Access Compliance Report

Public Rights-of-Way

Intersection ID: 12278	Main Street: SEIGLE_AV	Cross Street: VAN_EVERY_ST	Location: E
ADA ID: 896B792B09D3	Ramp Type: Perp	Initial Pass/Fail: Fail	Overall Compliance: No
		Severity Score: 12.5

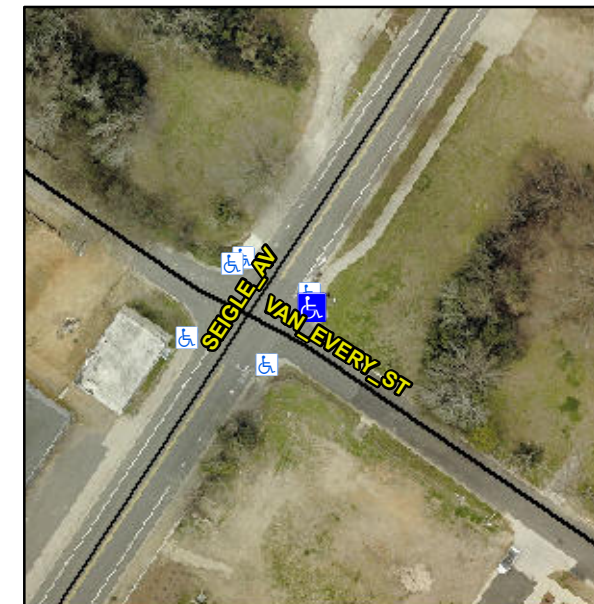
Not Found, R304.2.2

Compliance	Description	Data	Compliance	Description	Data
N/A	Ramp Length (in)	71.5	No	Ramp Slope (%)	10.1
Yes	Ramp Width (in)	53.0	Yes	Ramp XSlope (%)	0.7
N/A	Flare Type LT	N/A	N/A	Flare Type RT	N/A
N/A	Flare Slope LT (%)	N/A	N/A	Flare Slope RT (%)	N/A
N/A	Flare Traversable LT?	N/A	N/A	Flare Traversable RT?	N/A
N/A	Landing Length (in)	N/A	N/A	DWS Provided?	N/A
N/A	Landing Width (in)	N/A	N/A	DWS Contrast?	N/A
N/A	Landing Slope (%)	N/A	N/A	DWS Length (in)	N/A
N/A	Landing X Slope (%)	N/A	N/A	DWS Full Width?	N/A
N/A	Landing Curb? (Y/N)	N/A	N/A	DWS Offset (in)	N/A
N/A	Shared Landing?	N/A			
N/A	Gutter Ponding?	N/A	N/A	Gutter Slope (%)	N/A
N/A	Gutter Lip Ht (in)	N/A	N/A	Gutter X Slope (%)	N/A
N/A	Painted X Walk1?	No	N/A	Painted X Walk2?	N/A
	X Walk 1 Direction	To SW		X Walk 2 Direction	N/A
N/A	X Walk 1 Width (in)	N/A	N/A	X Walk 2 Width (in)	N/A
	X Walk 1 Slope (%)	5.0		X Walk 2 Slope (%)	N/A
	X Walk 1 X Slope (%)	3.1		X Walk 2 X Slope (%)	N/A

Remove & Replace Entire Ramp.
